Sum8 to ADC (2nd level) Patch Panel Front, changes made on 6/2/09.

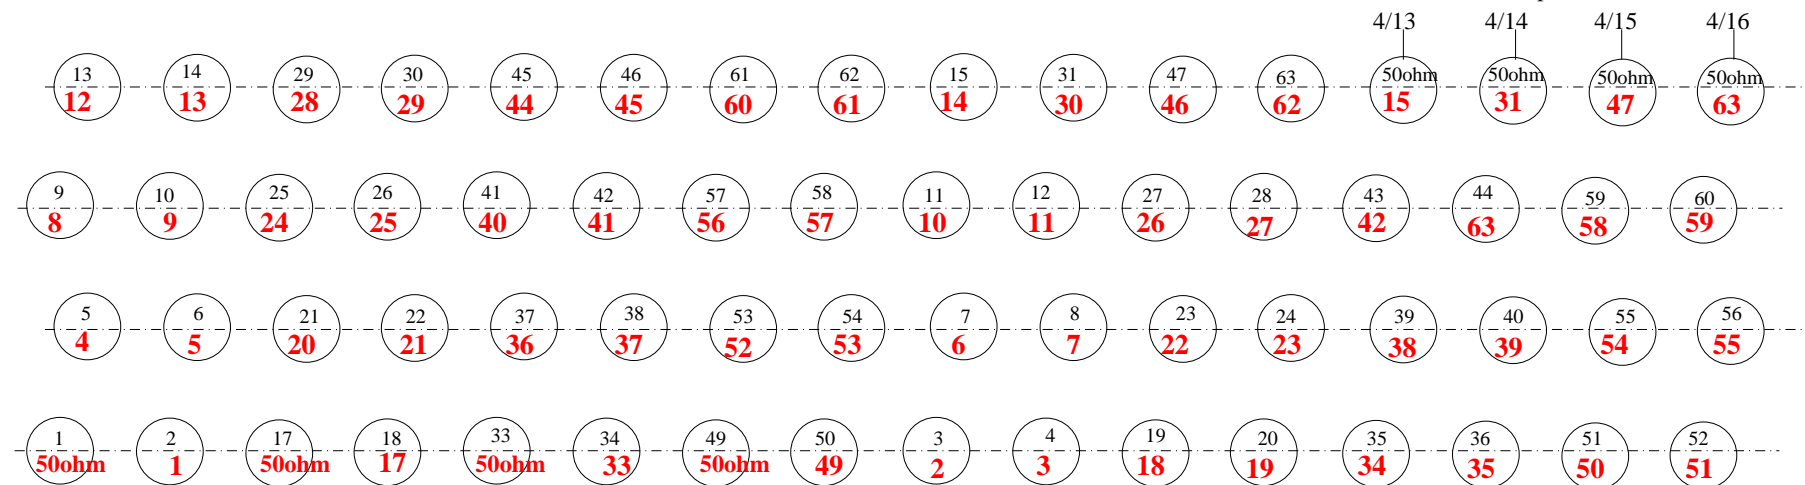
These are connected to
(from left) 4th Sum8
input

5
4 means this connector was originally connected to cable "TA 5", and now is connected to cable "TA4", that goes to the 2nd floor ADCs.
